To: Andrew Sutherland, Ph.D., SJRWMD
From: HSW Consulting, LLC
Ken Water, Ph.D., PH, Dean Mades, P.E., and Scott Emery, Ph.D.
RE: Contract 32927 / Work Order 03

Project Title: Independent Technical Peer Review
Minimum Levels Reevaluation for Sylvan Lake, Seminole County, Florida

HSW Project No.: 1BG900702

Figure 2. From MFL Report Appendix B.

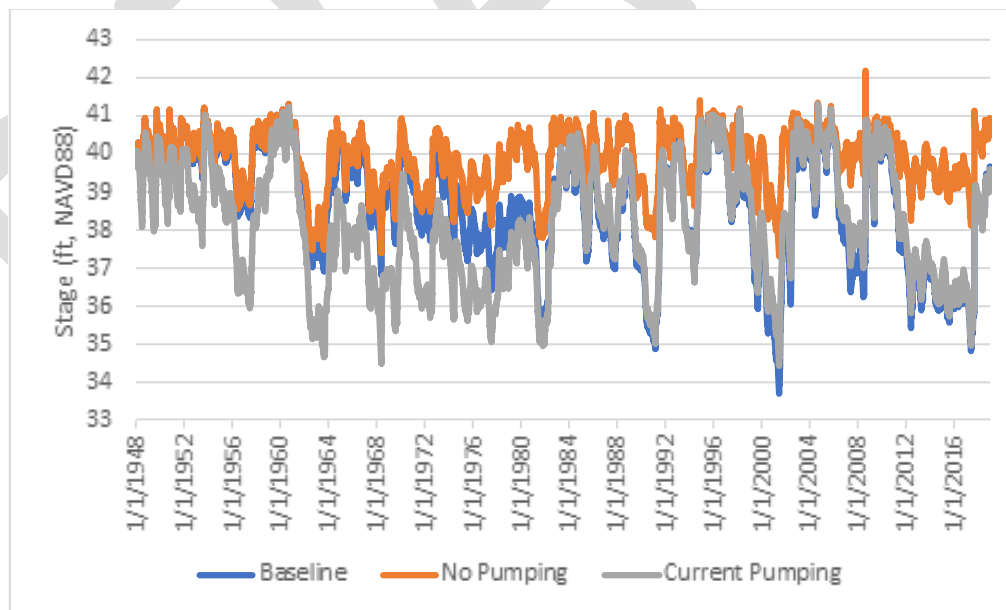
the 2003 steady-state head distribution which is associated with about 41 MGD of pumping within the 10-mile buffer and an undisclosed amount of pumping outside the 10-mile buffer zone (draft report Figure B-13). In comparison, the Calibration Period pumping within the 10-mile buffer averaged about 43 MGD.

B-17	Figure B-12	Consider adding the feature noted in the preceding comment on page B-16/P3.
B-18	Figure B-13	Does graph depict groundwater use within the 10-mile buffer? To support the 10-mile assumption, consider adding bars for total use within several other areas, such as Yankee Lake Basin, and 5-mile radius. See preceding comment on page B-16/P6.
B-18	1	Although a reference is provided for this important method (ECCTX modeling), insufficient information is provided for the reader to comprehend the linkage of the GW-SW systems. Consider summarizing here, or in a background section (see preceding comment on page B-3), other salient model characteristics such as areal extent, grid-cell dimensions, layers/hydrogeological units, boundary conditions, surface-water hydrography elements and return flow near Sylvan Lake. For example, it is noteworthy that the 180-acre lake area is equivalent to about 5 model square-grid cells that are about 1/4-mile on a side.

Figure 3. From MFL Report Appendix B

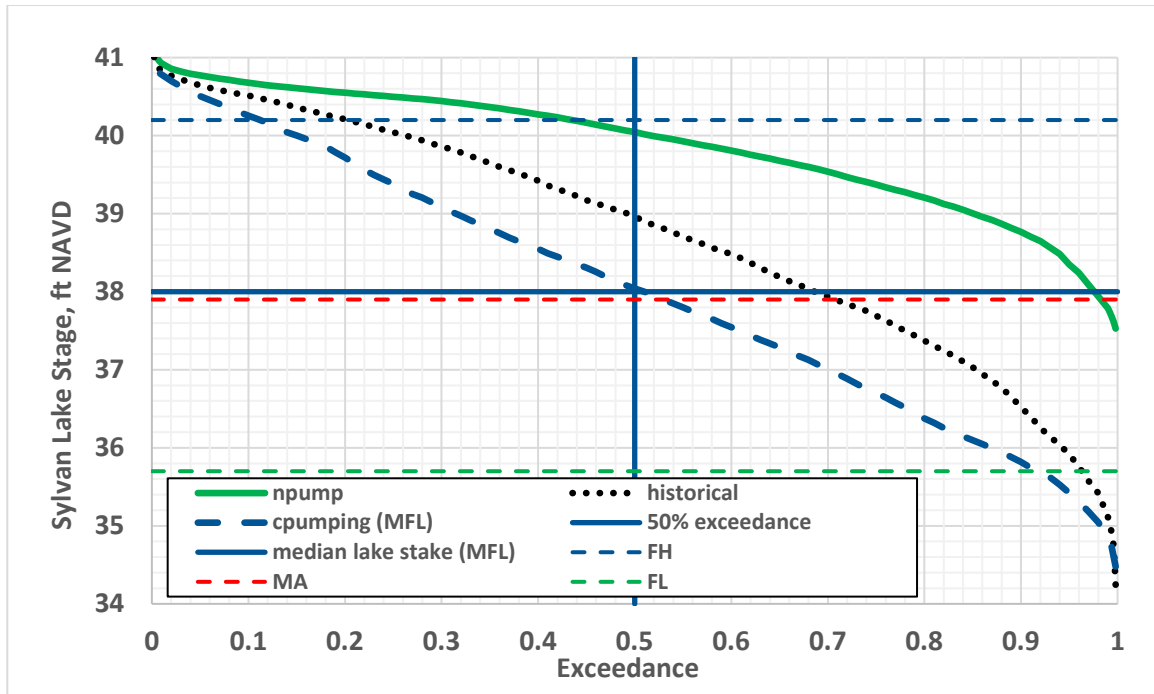
The word baseline shows up only in Appendix B, Figure B-17, and is synonymous with the historical record in this MFL. Other Districts view baseline as the historical record with the effects of withdrawals

Figures 2 and 3 depict the estimated historical regional pumping and the associated estimated lake level hydrographs based on different pumping scenarios, respectively.

Figure 4. No-pumping, historical (baseline), and current (MFLs) condition exceedance curves for Sylvan Lake, Seminole County, Florida

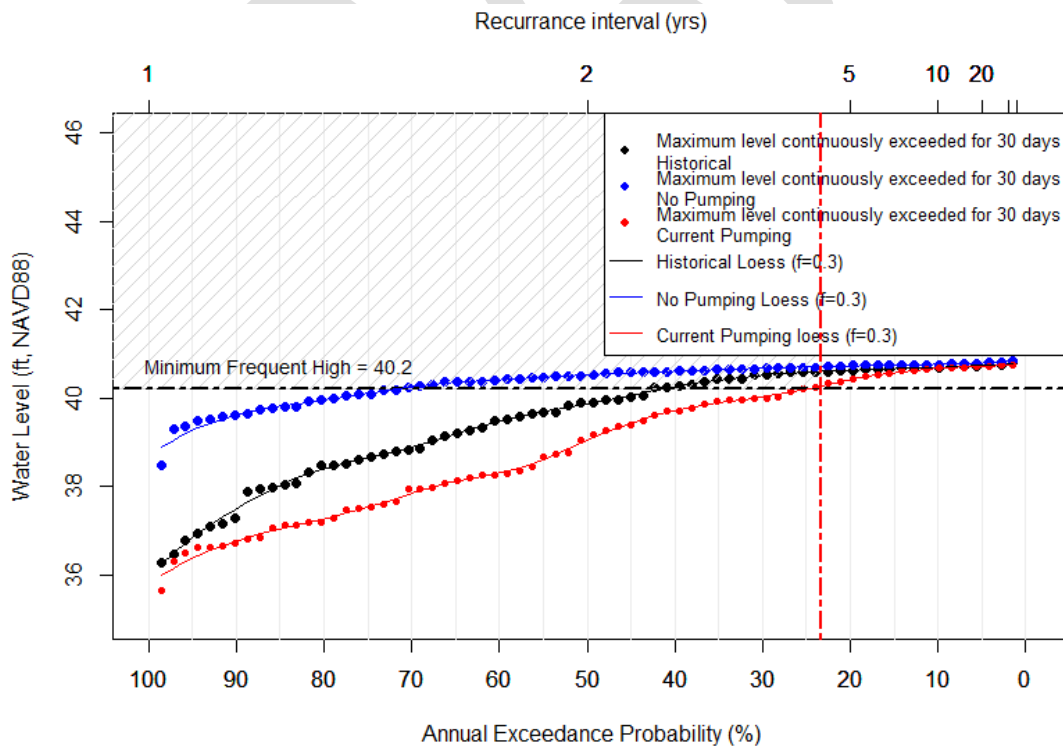
Figure 4 depicts stage duration curves for the pumping scenario data series. Note that the control structure limits the impact of withdrawals at the high stage end, and that impacts increase at progressively lower lake stage. At the median lake stage, about half of the impact occurs from the no-pumping to the historical pumping scenarios and the other half from historical to the current pumping (and the MFL) scenarios. At progressively lower lake stage, greater impact is attributed to historical withdrawals. The total estimated impact of pumping on lake level is about 2 ft at the median and 3.5 ft at minimum lake levels.

Figure 5. Minimum Frequent High (FH) Weibull plot

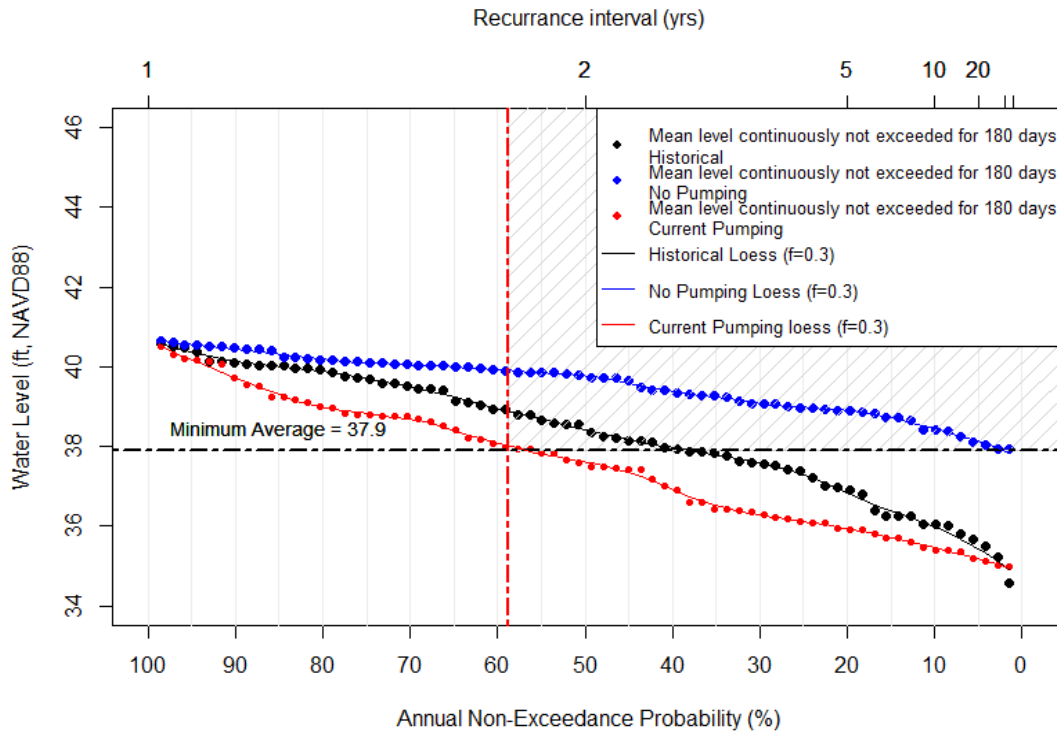
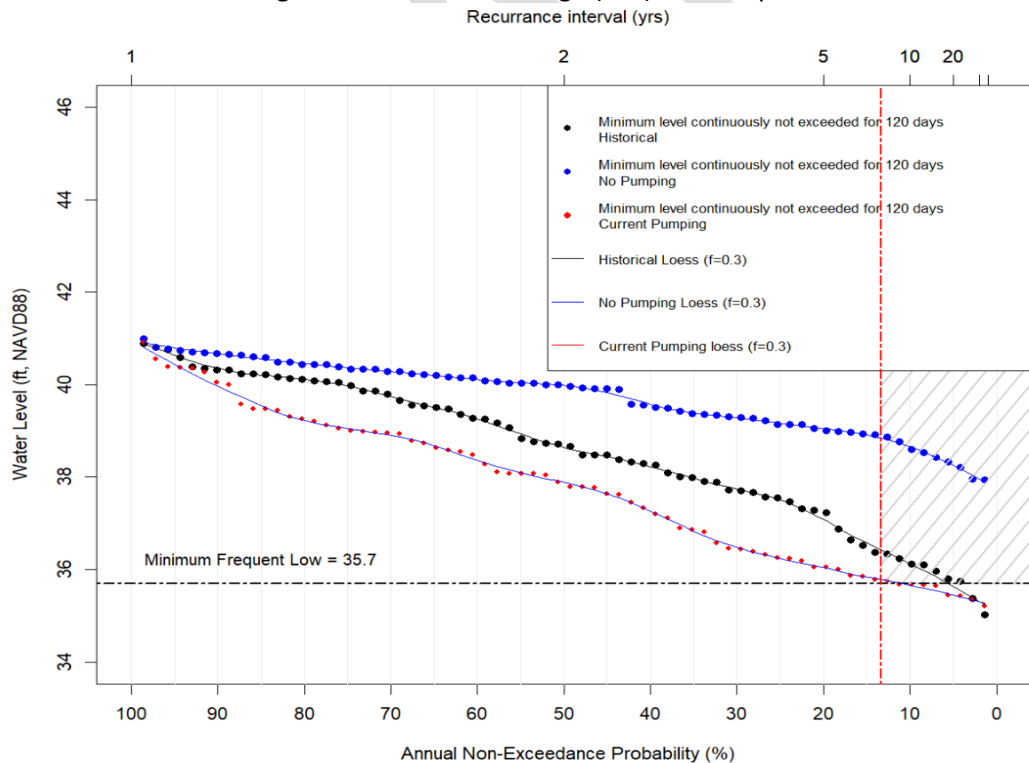
Figures 5 through 7 depict the Weibull plots associated with the three MFL metrics (FH, MA, and FL) and for the different pumping scenarios and the MFL scenario (i.e., current pumping). The Weibull plots provide information similar to the FDCs presented in Figure 4 but also support the District's approach of setting MFLs based on an allowable shift in the frequency of the key events (i.e., FH, MA, and FL).

- i. For clarity, consider adding information presented in Figures 3 – 6 to appropriate figures in the Sylvan Lake MFL Report and or appendices.
 - ii. Consider adding language that supports using the historical record as baseline, primarily as related to the position of wetland communities.
